Referral 5: Chadstone Activity Centre

Activity Centres Standing Advisory Committee Report

12 November 2024

Figure 3 Proposed change to catchment boundary

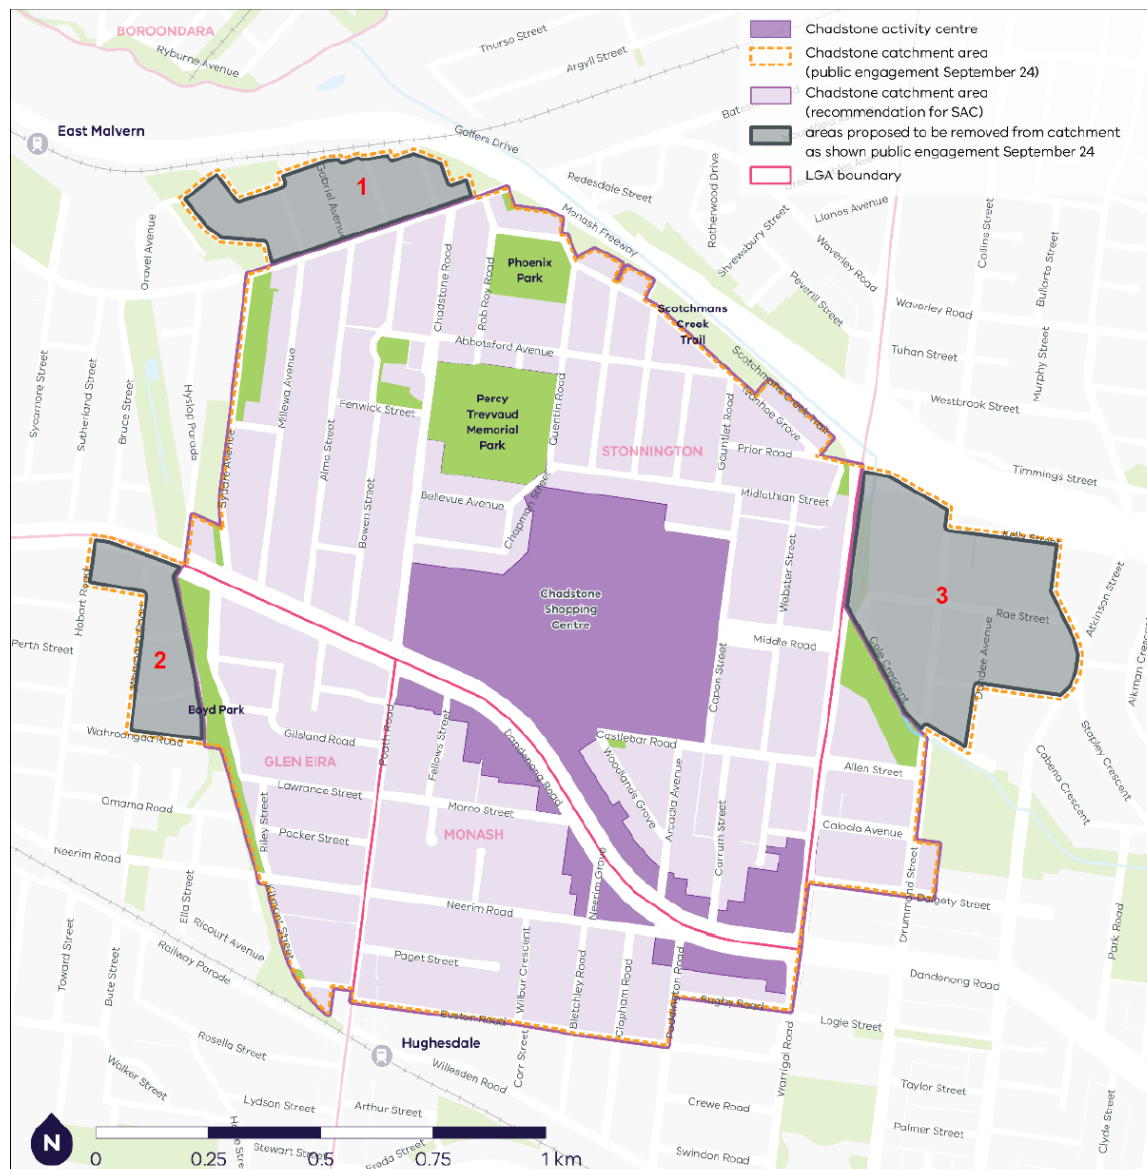
The VPA proposes to change the catchment boundary to exclude the grey shaded areas in Figure 2 for the following reasons:

Monash also submitted the catchment area should not be included in the Activity Centre Plan, suggesting a distance of 800 metres from the edge of the shopping centre is excessive. It specifically recommended removal of Area 3 on Figure 3, as it includes heritage areas and is separated from the Activity Centre by a significant physical barrier (Warrigal Road).

Glen Eira submitted the area west of Boyd Park (Area 2 on Figure 3) should be removed.

- exclude Areas 1, 2 and 3 identified in Figure 3 as they are too distant from the services within the Activity Centre that serve day to day needs (and are separated by physical barriers)
- exclude areas south of Dandenong Road and east of Warrigal Road, as these major roads present significant physical barriers to pedestrian access to the shopping centre
- measure the 800 metres walkable distance from the commercial services within the centre that serve day to day needs (not the outer edges of the carparks)
- exclude all Fringe Precinct areas and the Percy Treyvaud Memorial Park from the area from which the 800 metres is measured.
